REVISED TECHNICAL SPECIFICATION PAGES FOR
PROPOSED TECHNICAL SPECIFICATION CHANGES

INSTRUMENTATION SURVEILLANCE TEST INTERVALS,
ALLOWABLE OUT-OF-SERVICE TIMES, AND OTHER CHANGES

JPTS-90-010

JAMES A. FITZPATRICK NUCLEAR POWER PLANT

FIG. 4 I-1
GRAPHICAL AID IN THE SELECTION OF AN ADEQUATE INTERVAL BETWEEN TESTS

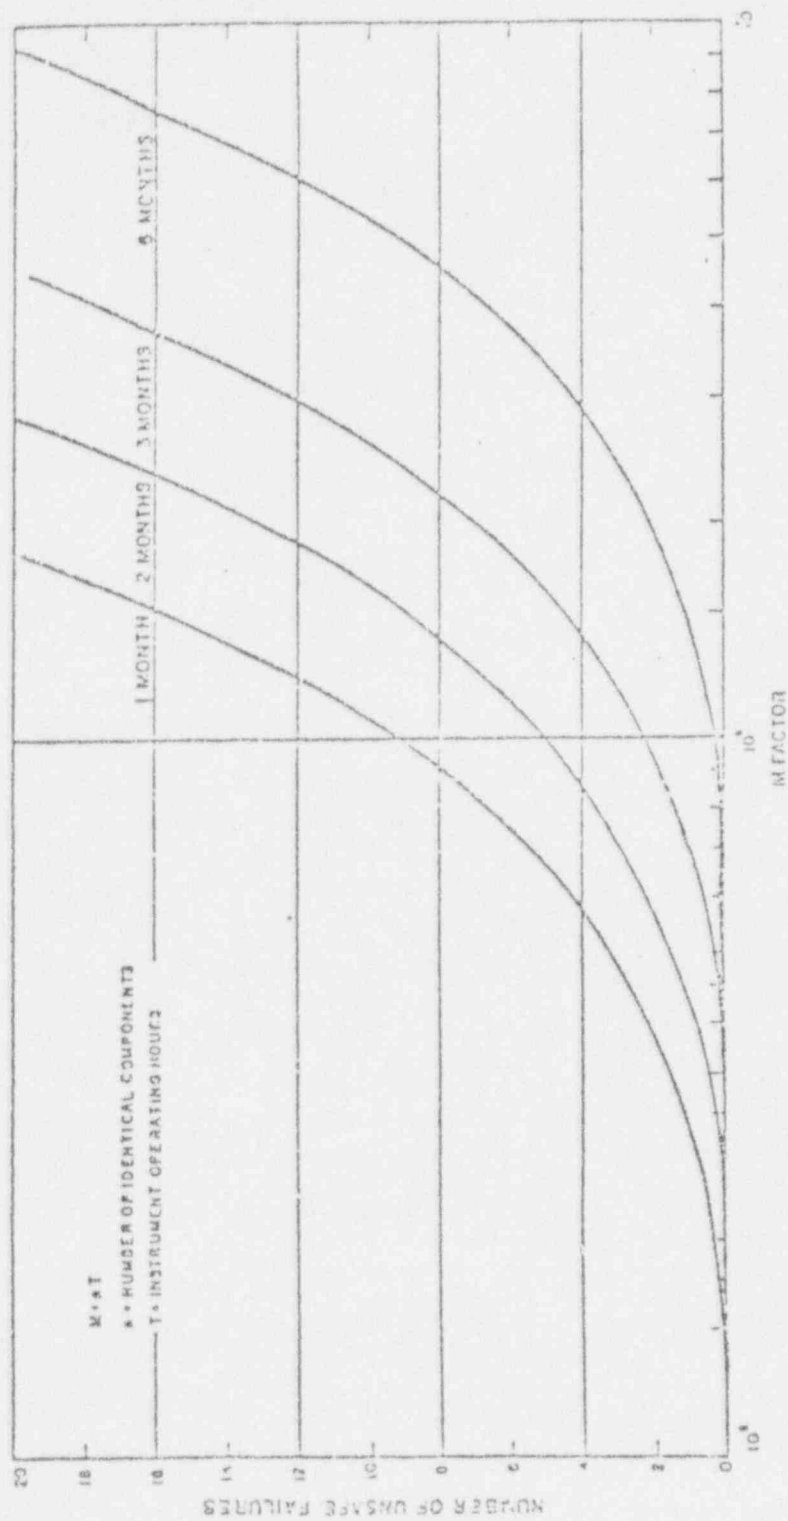
J. Figure 4.1-1, Page 48

Delete Figure 4.1-1 since it is referenced in text deleted by change F.6. (CAT 1)

Delete Figure

FIG. 4.2-1
TEST INTERVAL VS PROBABILITY OF SYSTEM UNAVAILABILITY

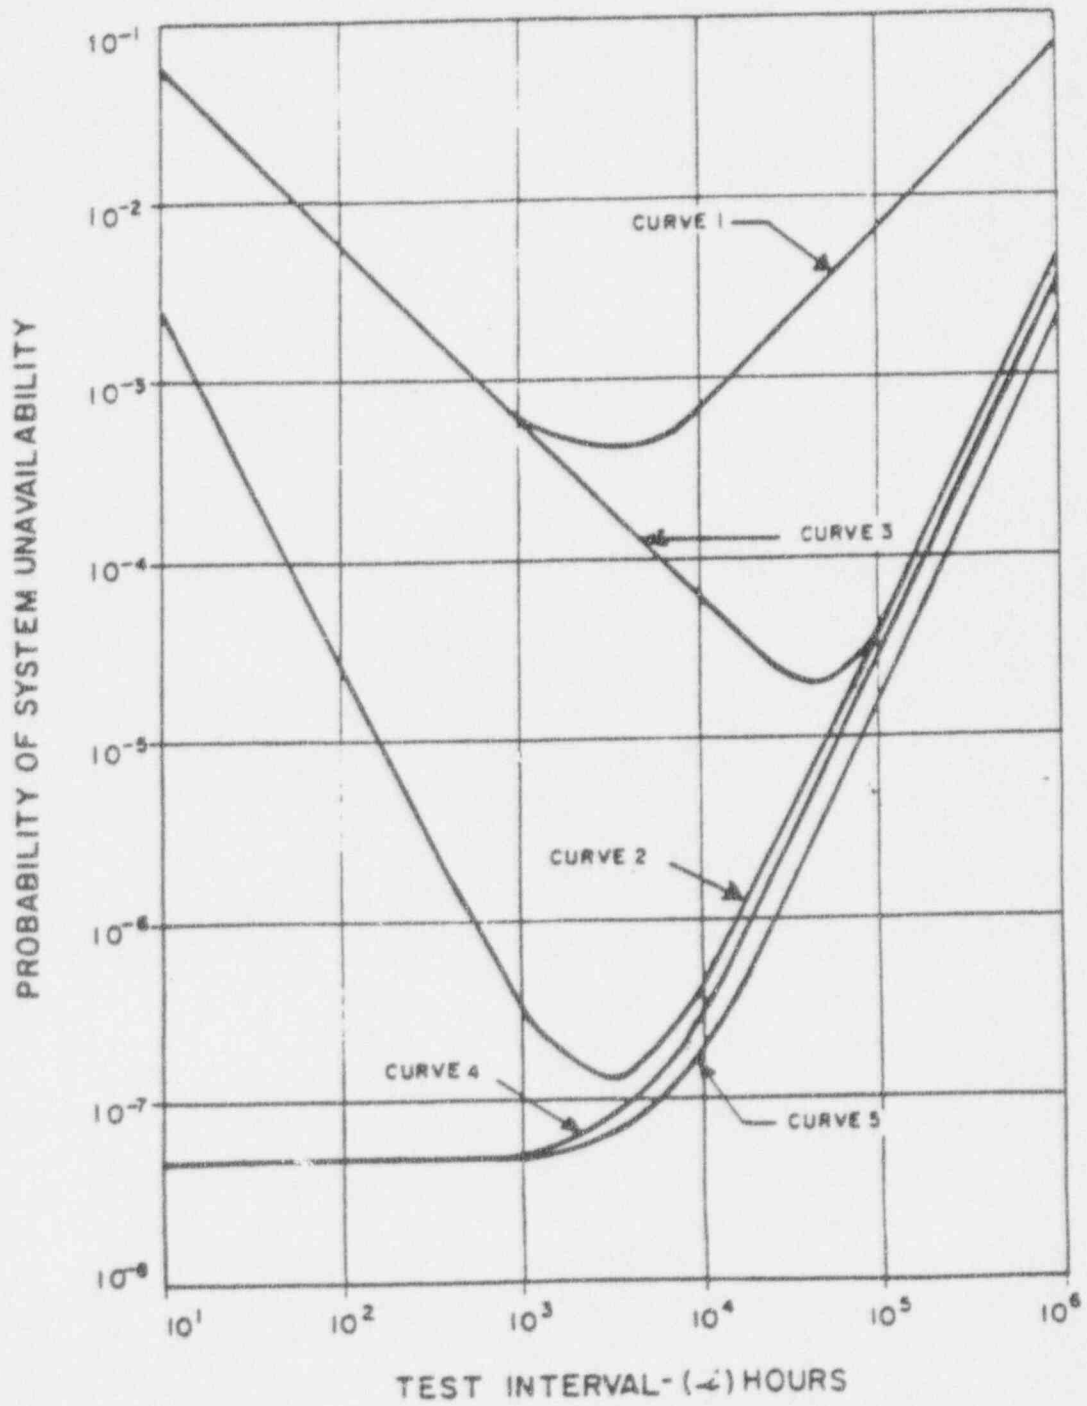
2. Revise the title of the table. (CAT 4)
- Y. Figure 4.2-1, Test Intervals vs. Probability of System Unavailability, Page 87
- Page 87: Delete Figure 4.2-1 since it is referenced in text deleted by change N.1. (CAT 1)

Delete Fig. 4.2-1
